PCI Design Handbook **ERRATA**

Seventh Edition

ERRATA

In 2010, the Precast/Prestressed Concrete Institute published the seventh edition of the *PCI Design Handbook—Precast and Prestressed Concrete* (MNL-120-10). Although careful efforts were made to provide an accurate document, some errors have been discovered. We suggest that you mark your seventh edition to reflect these errata so that the handbook is as accurate as possible.

Fig. 4.5.1 (Revised in accordance with 2011 Errata) Unsymmetrical shear walls.

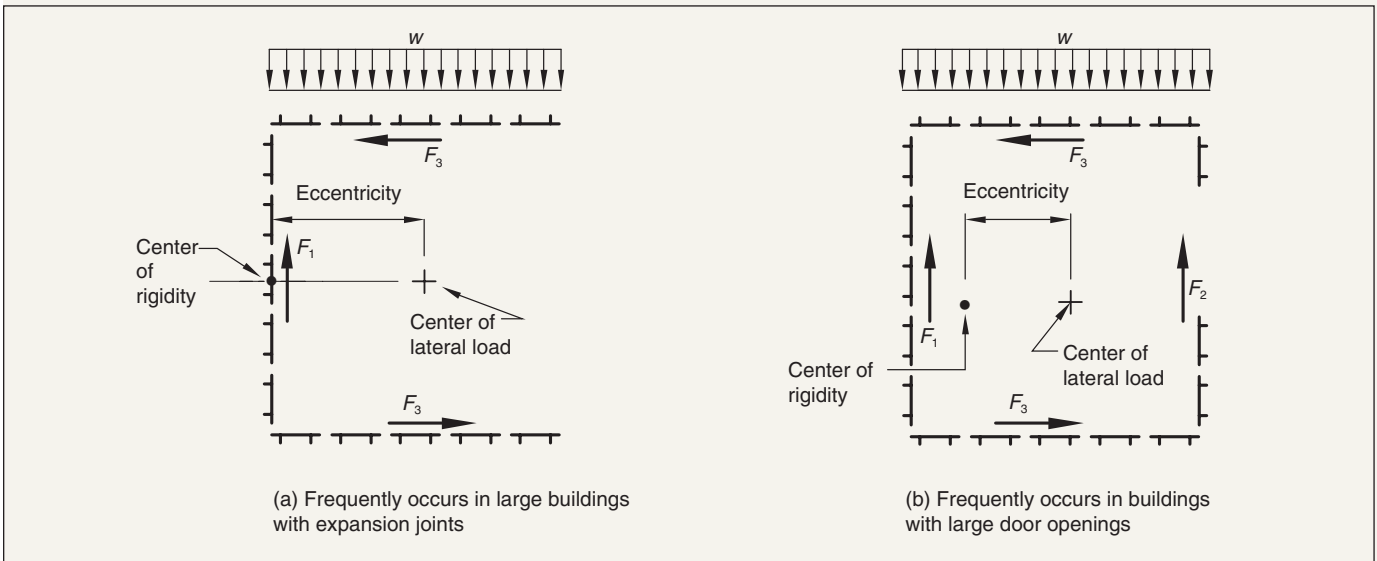
Page 4-22, Fig. 4.5.1: The locations of the center of rigidity and center of lateral load in the left diagram are not correct. The location of the center of lateral load in the right diagram is not correct. Replace with Fig. 4.5.1 as revised.

Fig. 4.8.4 (Revised in accordance with 2011 Errata) Collector force demand diagram for shear walls in a parking garage.

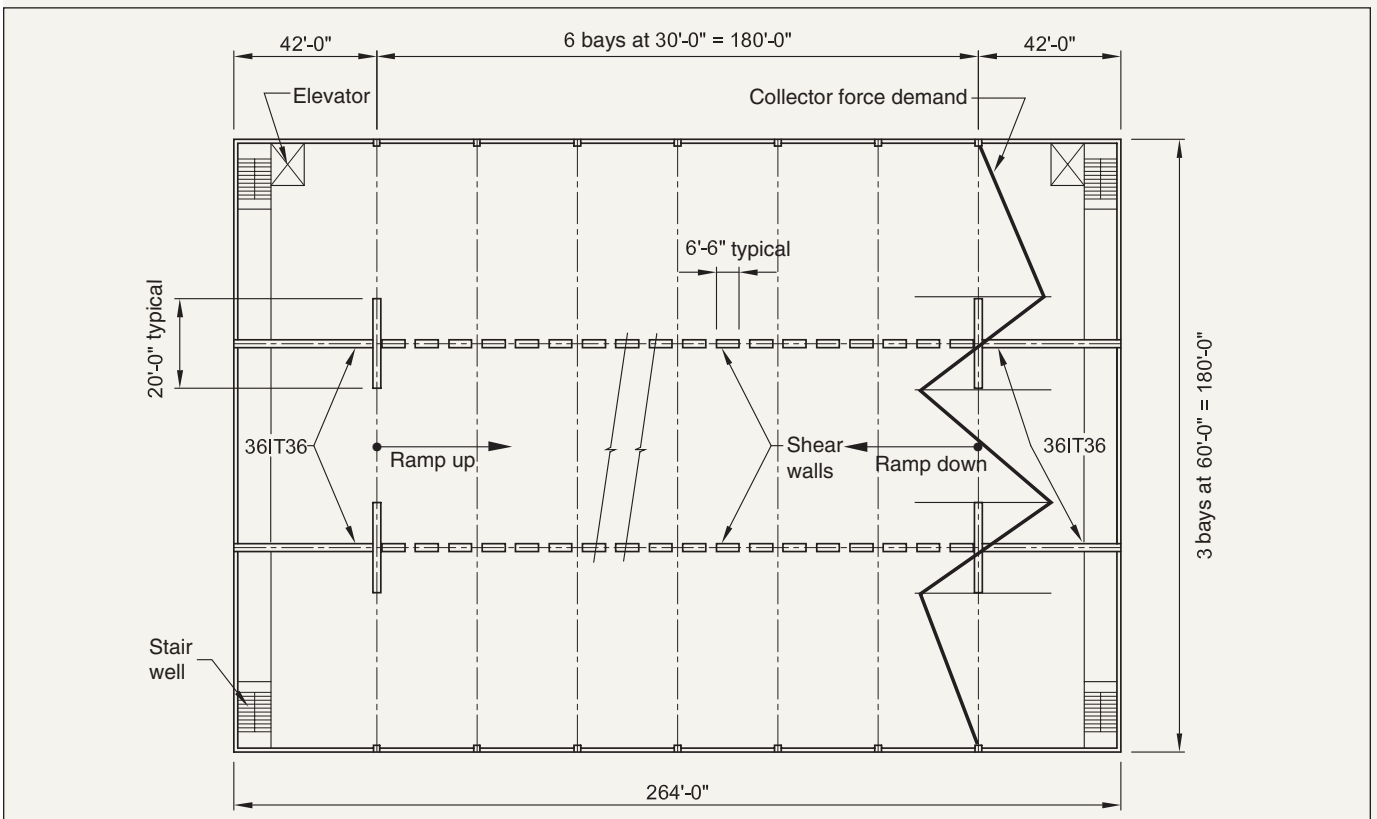
Page 4-58, Fig. 4.8.4: The peak line for the collector force demand should line up with the upper end of the lower shear wall. Replace with Fig. 4.8.4 as revised.

Fig. 5.9.7 (Revised in accordance with 2011 Errata) Typical pile interaction curve.

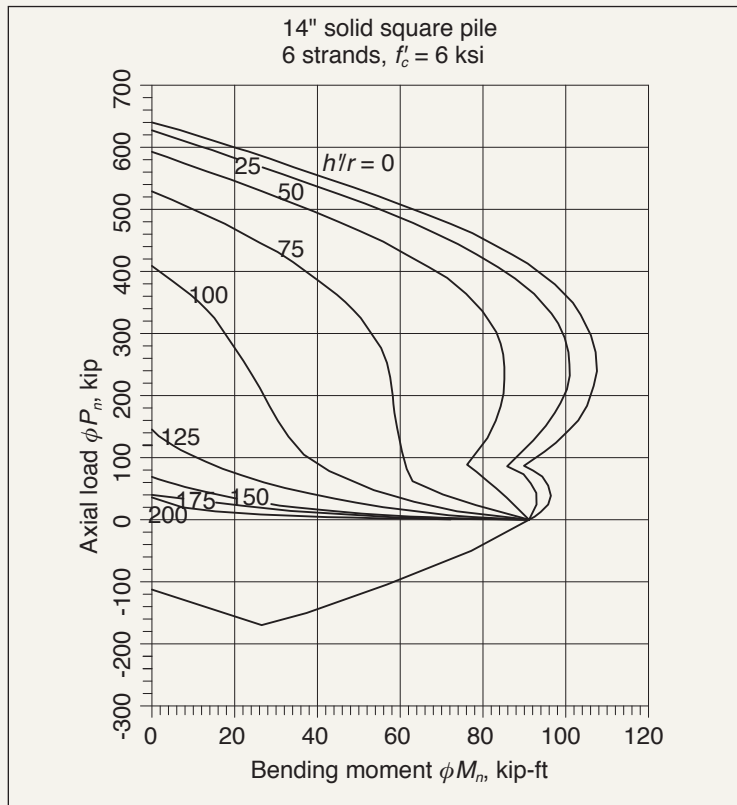
Page 5-116, Fig. 5.9.7: Curve for $h/r = 0$ should not have the slight uptick at zero bending moment. Replace with Fig. 5.9.7 as revised.

EXAMPLE 5.2.3.2 (Revised in accordance with 2011 Errata)

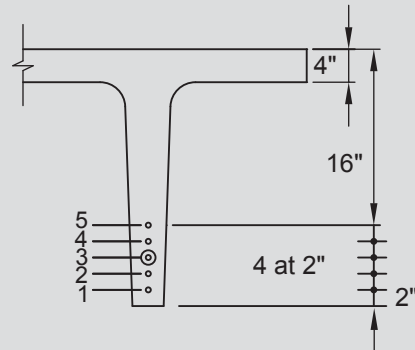
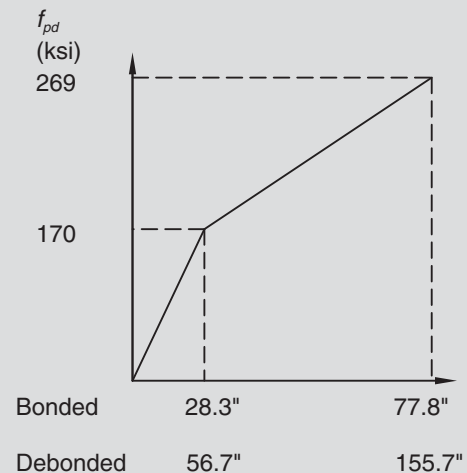
Page 5-38, Example 5.2.3.2: The example does not coincide with the text in that it does not properly account for the load in the partially developed strand. Replace with Example 5.2.3.2 as revised.

Note: Due to the presence of underdeveloped strand adjacent to fully developed strand the assumption of strain compatibility is not valid at this section. At capacity the underdeveloped strand will slip while maintaining partial development as necessary for the fully developed strands to adequately strain in order to yield.

$$T = 8(0.153)269 + 2(0.153)197.3 = 389.6 \text{ kip}$$

$$a = \frac{T}{0.85f'_c b} = \frac{389.6}{0.85(5)(120)} = 0.76 \text{ in.}$$

$$M_n = T \left(d - \frac{a}{2} \right) = 389.6 \left(20 - \frac{0.76}{2} \right) = 7644 \text{ kip-in.} = 637 \text{ kip-ft}$$

Design Aid 6.15.3 (Revised in accordance with 2011 Errata)
Minimum Length of Weld to Develop Full Strength of Bar. Weld Parallel to Bar Length^{a,b,c}

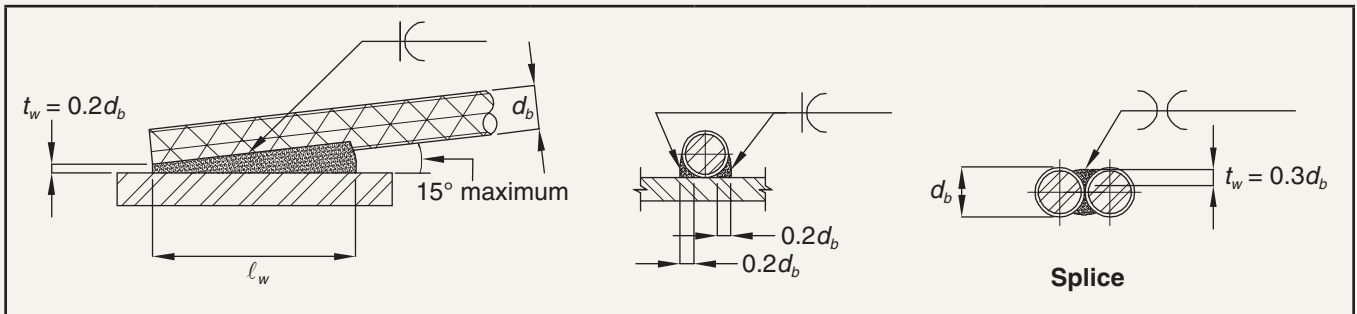
Page 6-102, Design Aid 6.15.3: Replace with Design Aid 6.15.3 as revised.

Design Aid 6.15.4 (Revised in accordance with 2011 Errata)
Size of Fillet Weld Required to Develop Full Strength of Bar. Butt Weld.

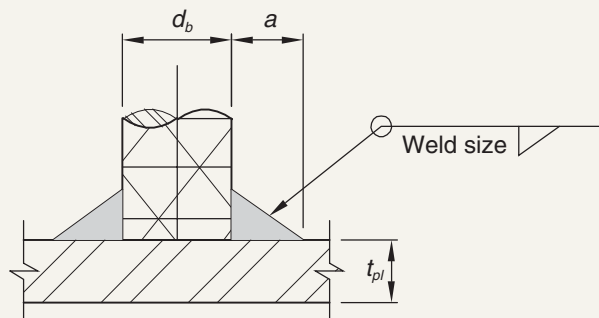
Page 6-103, Design Aid 6.15.4: Replace with Design Aid 6.15.4 as revised.

Design Aid 6.15.5 (Revised in accordance with 2011 Errata)
Size of Fillet Weld Required to Develop Full Strength of Bar. Weld Through Hole.

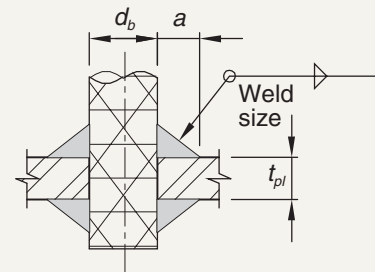
Page 6-104, Design Aid 6.15.5: Replace with Design Aid 6.15.5 as revised.
